APPENDIX A

DEIS COMMENTS AND RESPONSES (INCLUDING PUBLIC HEARING)

Index of DEIS Comments and Responses

Bicycle/Pedestrian Facilities
Figure 3-24

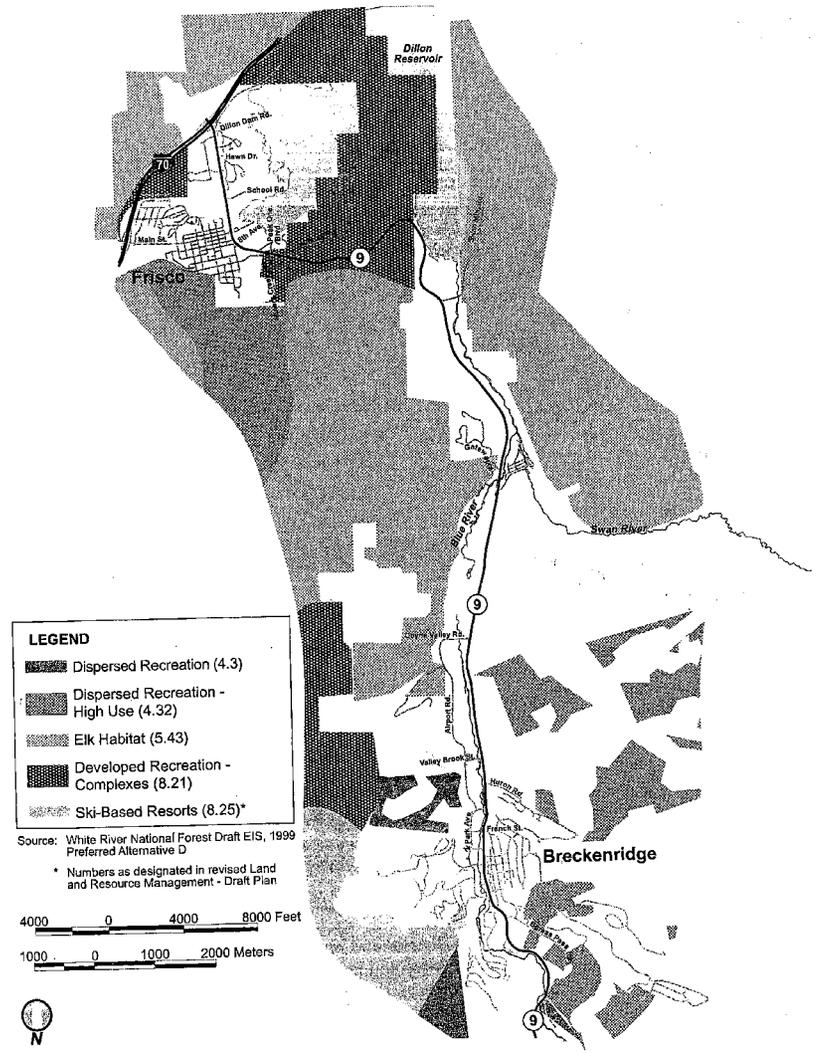
Page 3-55 - Figure 3-24 Bicycle/Pedestrian Facilities. Does not accurately show Colorado Trail. There is an error in showing paved pathways at the Dickey Day Use area, a trail segment south of Dickey Day Use Area north of Frisco-Farmers Korner Trail, and a trail segment north of Gateway Drive. The trail at the Dickey Day Use Area is an unpaved trail. (See attached edited map).

US Forest Service Management Prescription Areas
Figure 3-3

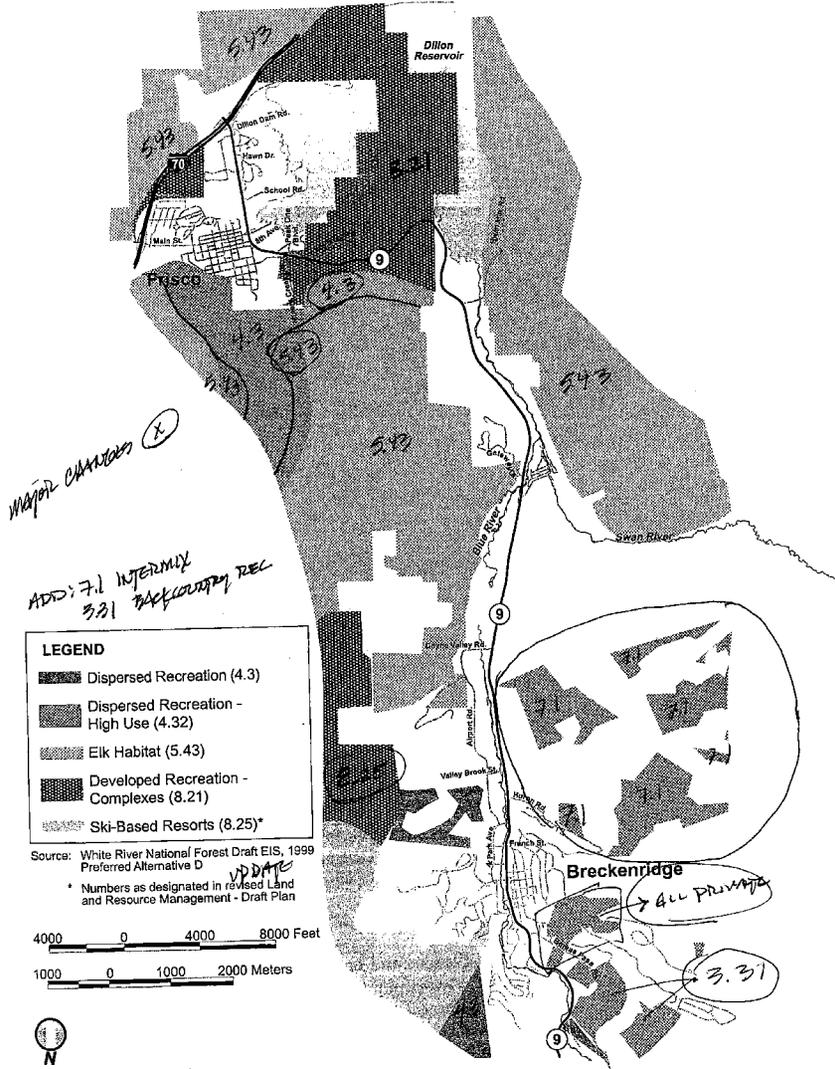
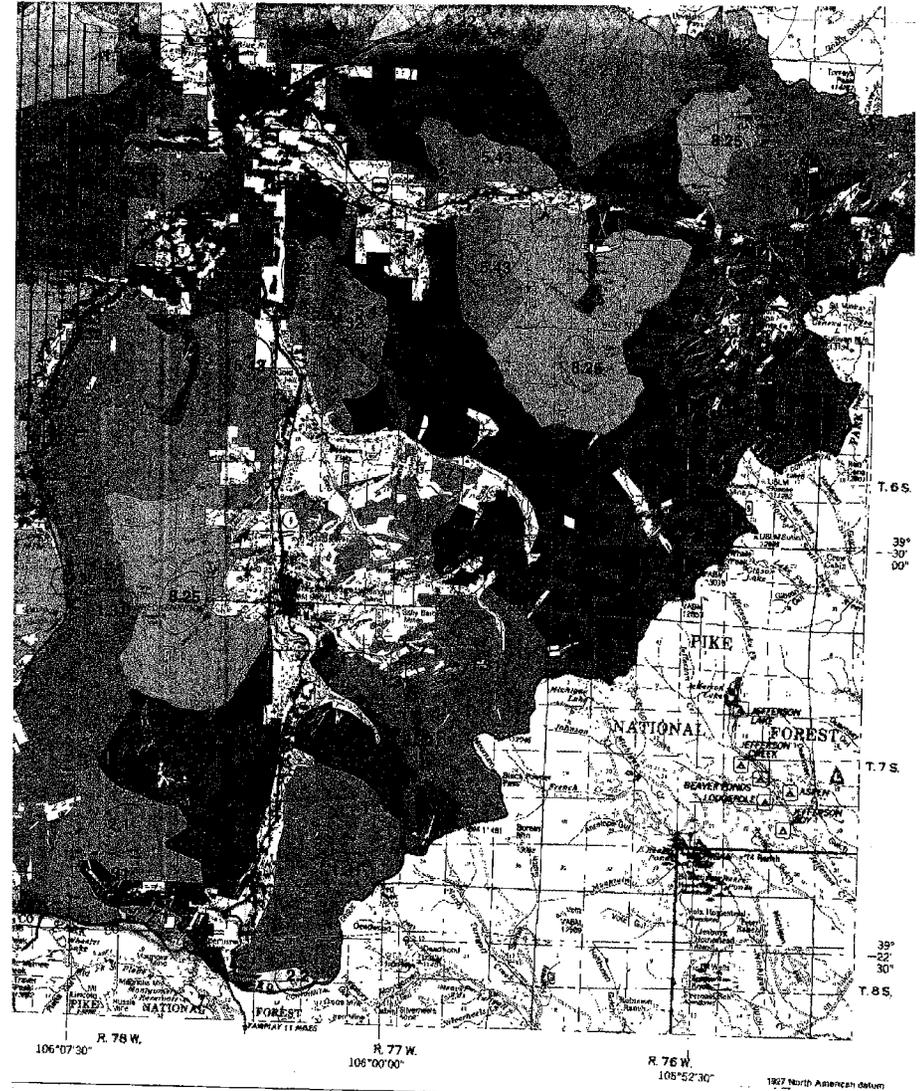
Page 3-5 – US Forest Service Management Prescription Areas. The information in Figure 3.3 should be updated to reflect the approved Forest Plan. Enclosed is an edited Figure 3.3. In addition to the management prescriptions indicated on page 3-6 there should be a short description of the Intermix (7.1) and Backcountry Recreation (3.31) management prescription (attached is a copy of the pages from the Forest Plan related to the 7.1 and 3.31 areas).
